Service Bulletin SB0047

Date: December 2002
From: Capstone Technical Support
Subject: Reconfigure Corner Grounded Delta Configuration

Figure 1. Existing Corner Grounded Delta-to-Wye Configuration

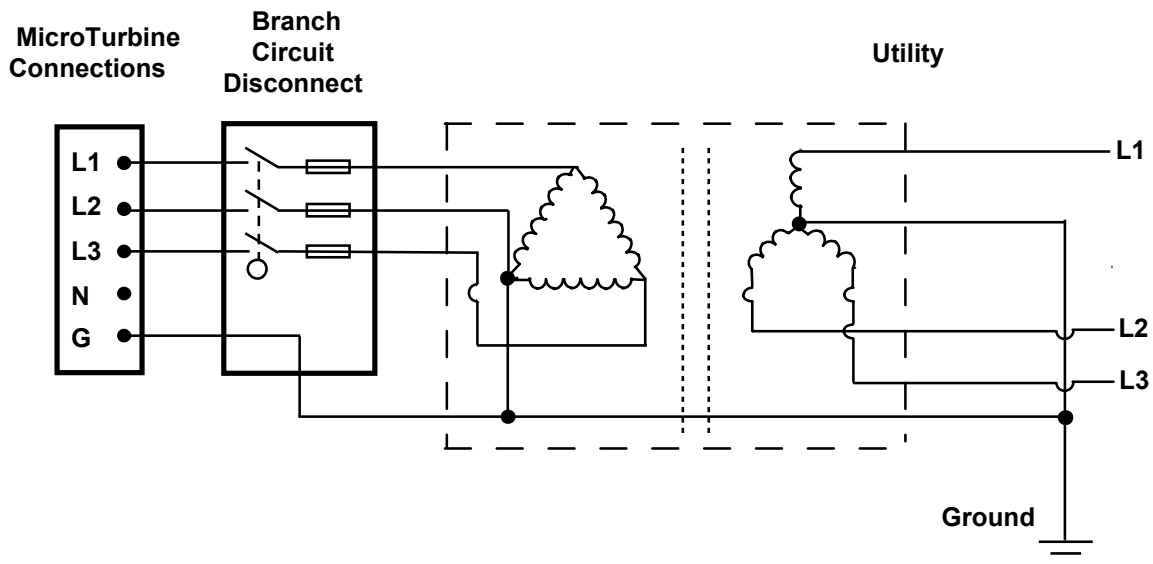
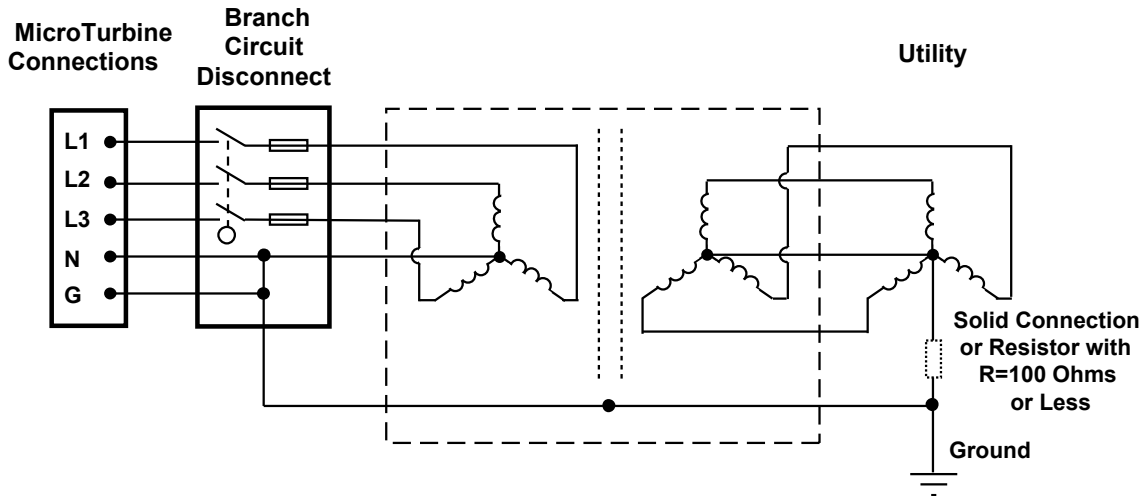
A C30 Standalone system operating in a corner-grounded Delta electrical configuration creates high levels of common mode voltage to components within the C30 Battery Controller Transient (BCT). These large voltages can cause excessive heating of board level components - ultimately resulting in premature failure of multiple MicroTurbine components or collateral failure of components in MultiPac-connected systems.

The result of ineffective grounding creates a failure from the high voltage bus to the low voltage bus on the BCT Power Board. Secondary failures of the Digital Power Controller (DPC) Control Board, Personality Modules (PMs), and other low voltage components will also occur.

To prevent failure, an installation configured corner-grounded delta must be reconfigured to the Wye configuration. Per Capstone approved installation, replace the Delta transfer with a Wye transformer connecting the high voltage wiring as shown in Figure 2. When configured in a Wye configuration, the MicroTurbine will be operating in its designed configuration and comply with UL1741 standard for grid interconnection.

Figure 3. Revised Delta-to-Wye Transformer Configuration
 (does not conform with UL1741)

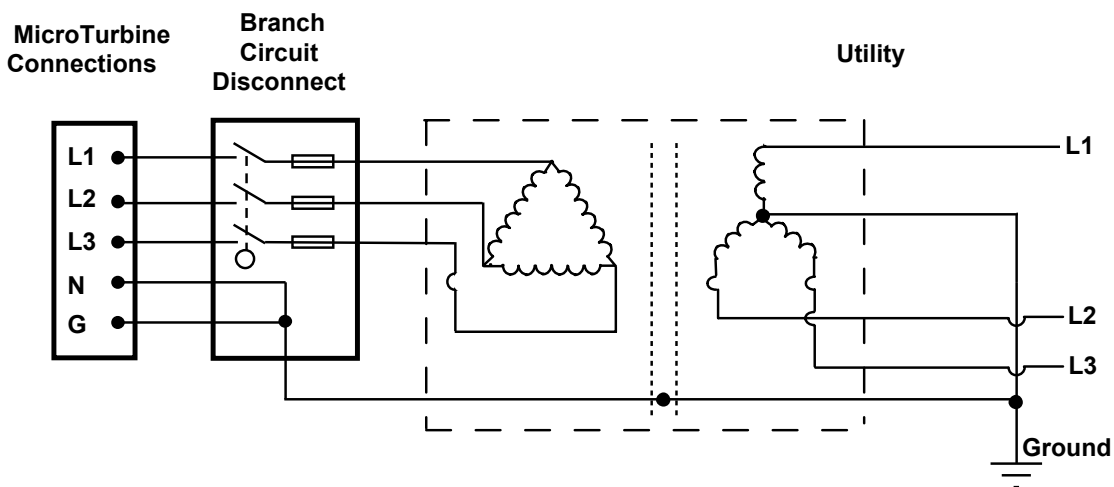
An alternative solution to continue uninterrupted operation with a Delta transformer for existing installations only is shown in Figure 3 below. To modify the configuration, remove the corner ground from the Delta winding and connect a neutral-to-ground connection at the branch circuit disconnect. Any external power metering equipment may only be installed on the utility Wye, and not between the MicroTurbine and Delta transformer. As described in the MicroTurbine Electrical Installation (410009) manual, a MicroTurbine installed in a Delta configuration does not comply with UL1741 standard for grid interconnection.
